OFFICIAL STEERING & SUSPENSION OF NASCAR®

**OE ball joint fails prematurely**

**MOOG® Problem Solver®  
Lower Ball Joint K3199/K80767**

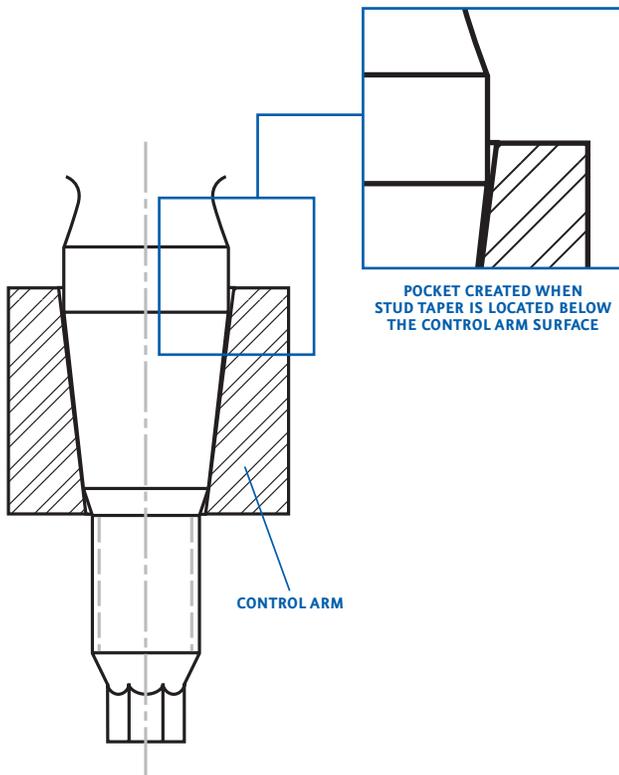
Ball joint boot failures can cause corrosion, accelerated wear and possible joint separation. Failure can be traced to a slight gap between the ball joint stud and control arm. The gap or pocket accumulates moisture, promoting corrosion of the ball joint stud and control arm tapered hole. The corrosion generated by the pocket penetrates under the dust boot, wearing at the sealing surface of the boot. Once exposed to the elements, the sealed, non-serviceable ball joint quickly degrades and fails.
